B500B & G500S
ASSEMBLY DWG NO: B627 A RE
11-2-90
STARTING SN GG 010001
ENDING SN
G500S

B500B
STARTING SN BPO10001
ENDING SN

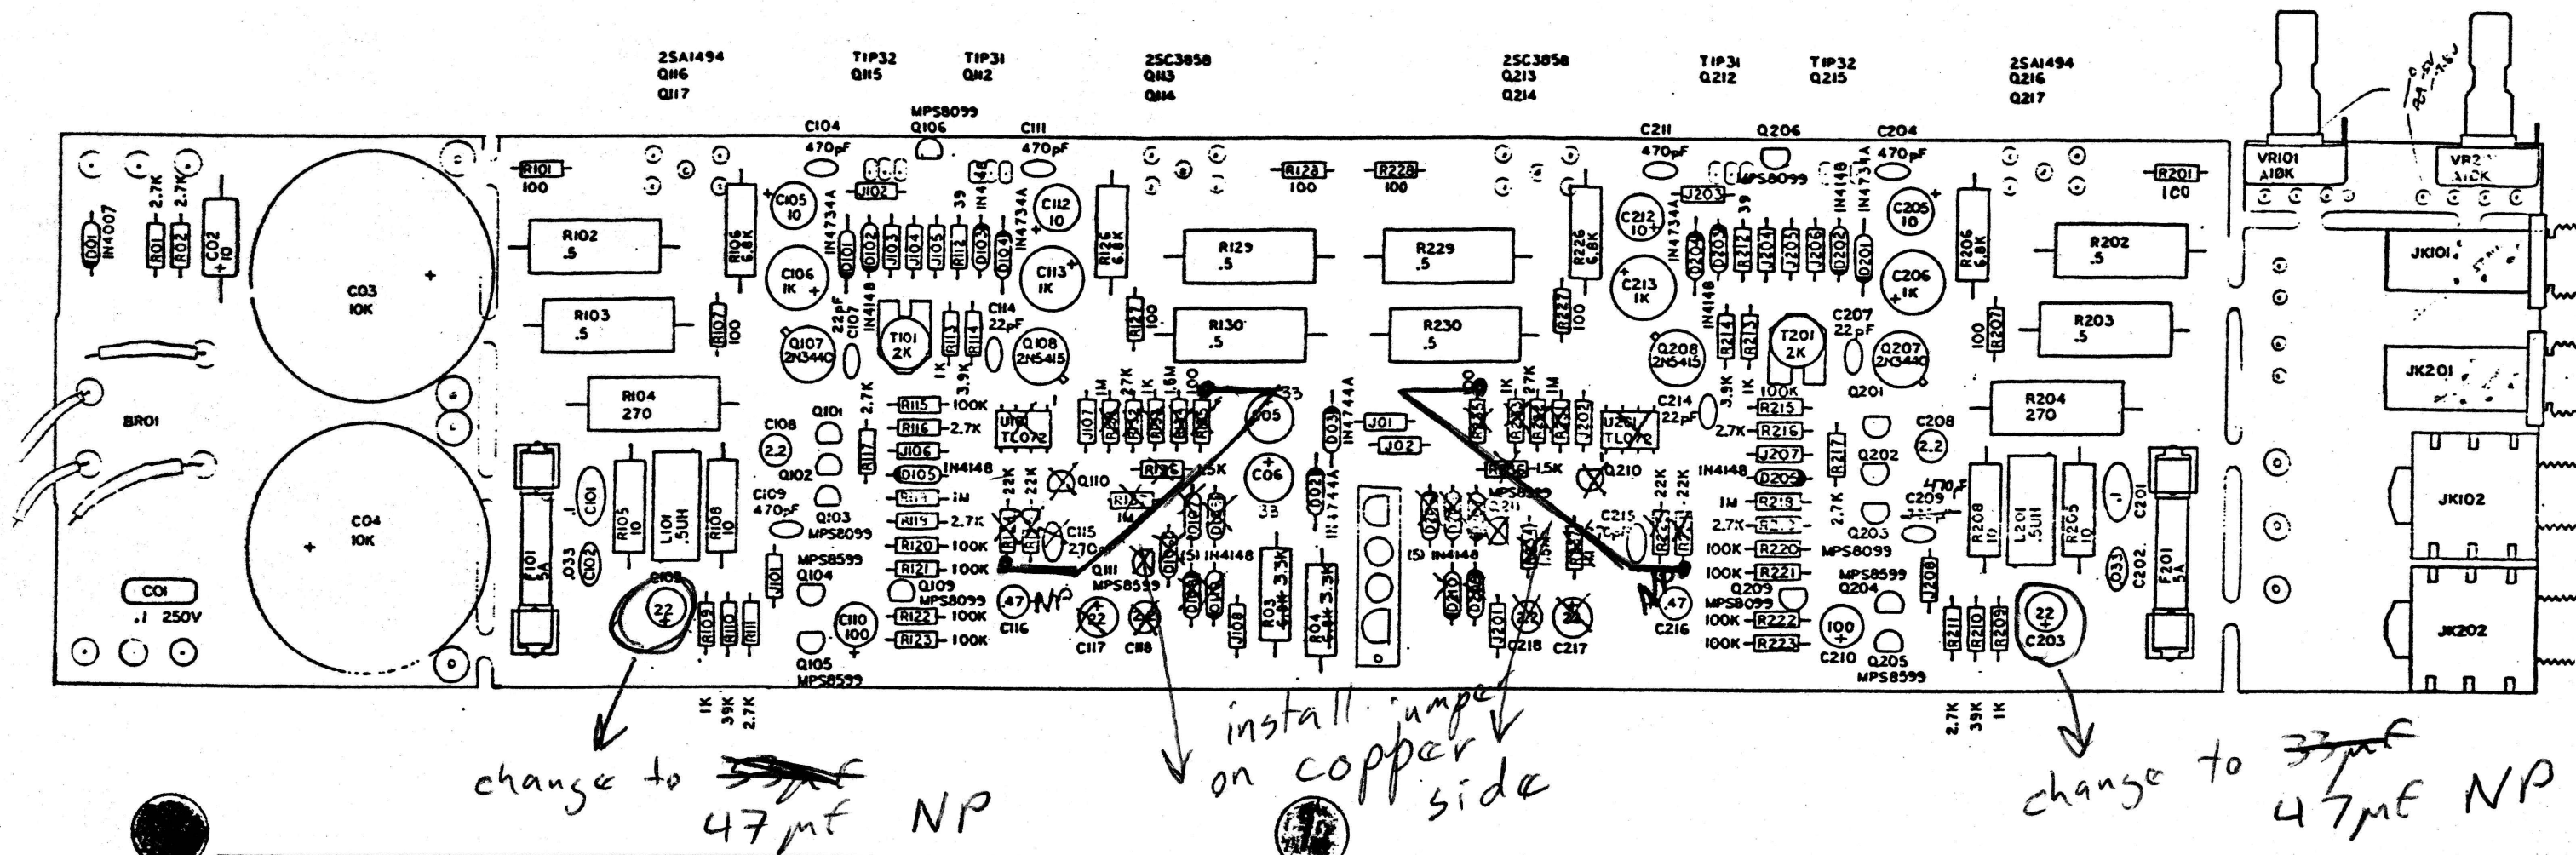
stop 3

change to ~~337~~ 47 mt NP

install jumper
on copper side

↓
change to ~~33μF~~
47μF NP
